Our Case Number: ABP-316272-23

Re: Bus Connects Templeogue/Rathfarnham to City Centre Core Bus Corridor Scheme
Templeogue/Rathfarnham to City Centre

**BusConnects Templeogue / Rathfarnham to City Centre CBC
Objection to proposed Compulsory Purchase Order - 10 Rathfarnham Wood,
Rathfarnham, Dublin 14 - Plot List: 1018(1).1d, 1018(2).2d
Submission on (1) Planning Application in respect of and (2) Proposed CPO of
Woodland area of Rathfarnham Castle Park – Plot List: 1001(1).1f; 1001(2).2f**

**BusConnects Dublin Templeogue / Rathfarnham to City Centre CBC
Submission on Planning Application in relation to the Proposed Scheme
Objection to proposed Compulsory Purchase Orders
Rathfarnham Castle Park
Entrance to Rathfarnham Wood Estate**

Close up view of Fig 13.1 – Surfacewater study area – showing no watercourse marked beside RCP although it is an open watercourse just inside the RCP wall where it will be directly built over. This is despite the fact that the maps at Fig 14.5 and Fig 14.13 clearly show the Glin River and duck pond.

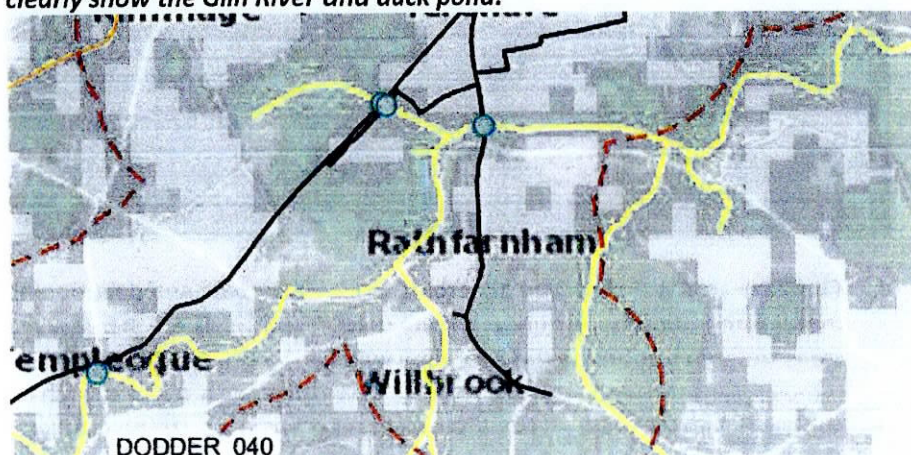
Yet when it comes to the actual environmental study areas, the Glin River and duck pond are not included. They have clearly not been evaluated or even considered. We cannot understand this glaring omission and clear breach of the Water Framework Directive.

Image 2.14 from Chapter 2 of the EIAR showing minimal impact from Grange Road to Rathfarnham Road / Fergus Road:

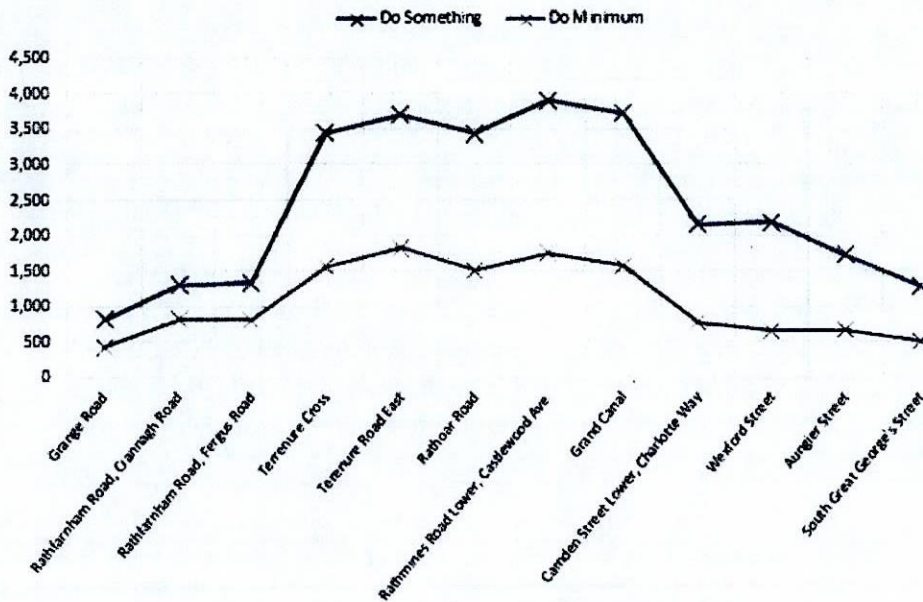
The projections show that the proposed reductions in journey time due to BusConnects will be minimal. Image 2.14 in Chapter 2 of the EIAR shows that the BusConnects scheme would have a far lesser impact around Rathfarnham than it would at other areas in any event.

Fig 12.1.3. - Ecological Study Areas: Aquatic and Riparian Survey Site:

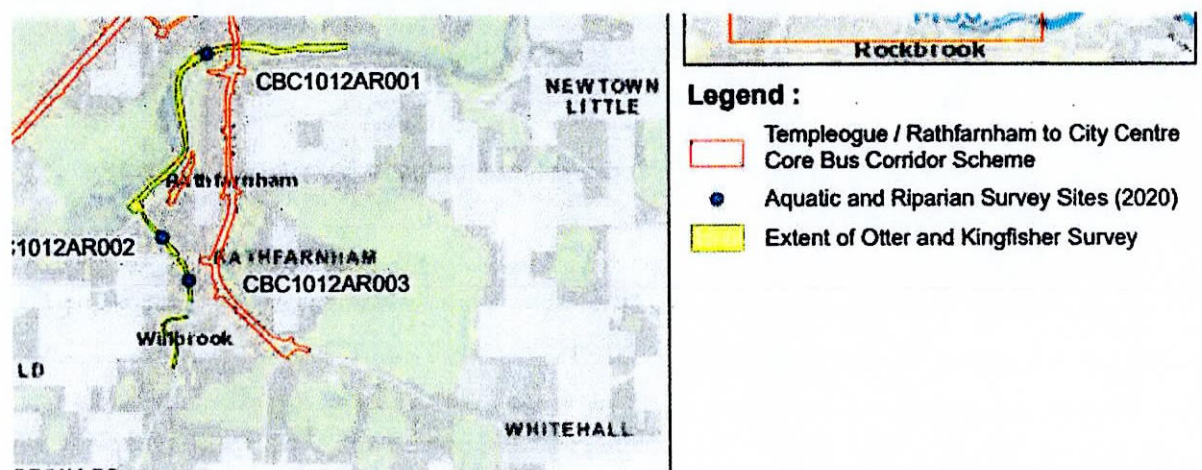
It is clear that neither the Glin River nor the pond were surveyed for otters or kingfishers. This is despite the fact that a kingfisher has been spotted in the Park, most recently on 23/7/23 and the Glin River / Whitechurch Stream is a known otter habitat.

Image 07 in Appendix 14.1 notes the presence of an apparently “dry” stream close to Butterfield Avenue (it is an active watercourse) yet completely fails to consider that there is a pond in the Park and a water source, the River Glin, constantly feeding and draining that pond!

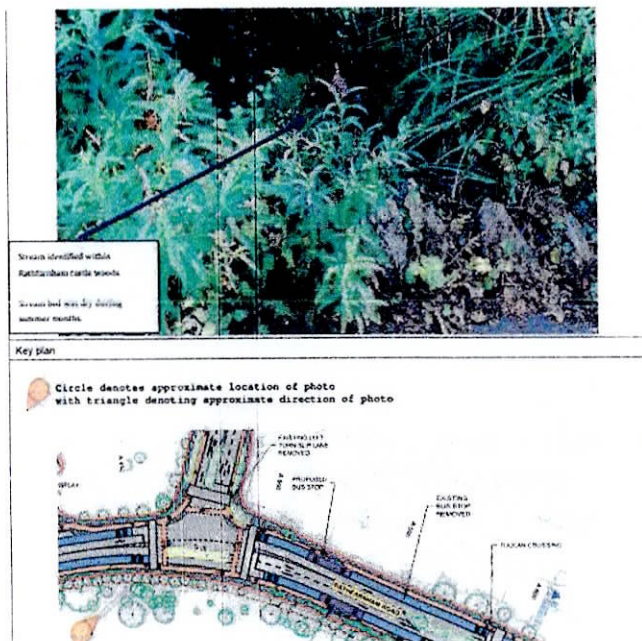
However it can be seen from the above table that the only stream in RCP identified in this survey was thought to be running “adjacent to the proposed bus corridor”, not actually under the corridor at two locations. See below indicator from Image 07 of where the photo was taken, close to Butterfield Avenue:

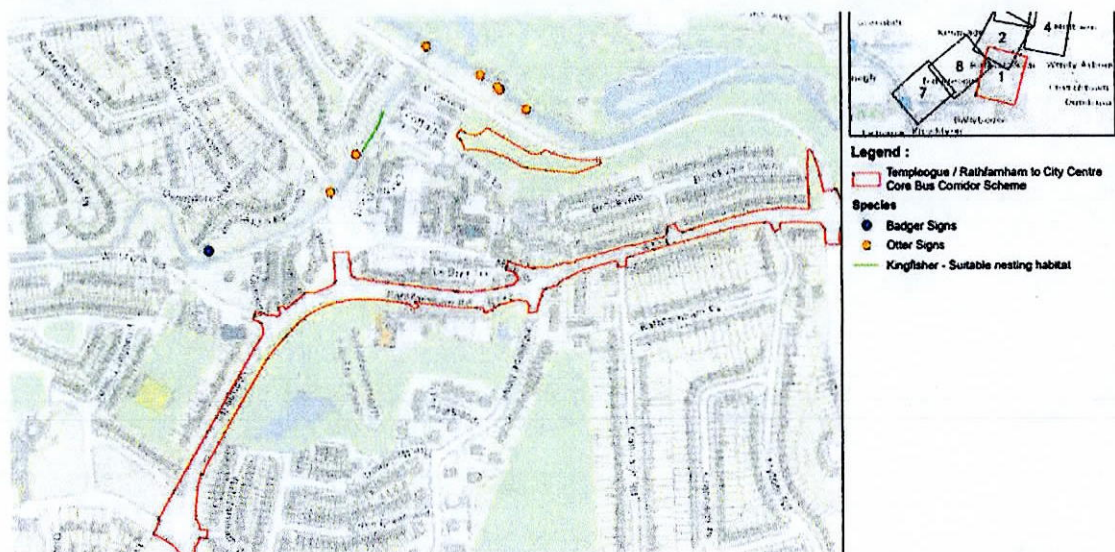
- *No evidence of amphibians or reptiles; [there are plenty of frogs in RCP, as can be seen from the photo above so we cannot understand this] and*
- *A total of 75 breeding bird species and 30 species with breeding and wintering bird populations [again, note the photos of the grey heron and black headed gull – Rathfarnham Castle Park has simply not been reviewed from this perspective; there are very many wild birds in the Park, including the two current families of tufted ducklings and numerous mallards].*

Fig 12.9 - Mammal, Aquatic and Riparian Survey Results - Note that otter and badger signs were found in the nearby area, yet RCP, a particularly important wildlife habitat with an active watercourse and a pond rich in aquatic life, wasn't even surveyed. Note also that RCP was not surveyed as a suitable kingfisher nesting habitat, although a kingfisher has been seen very recently:
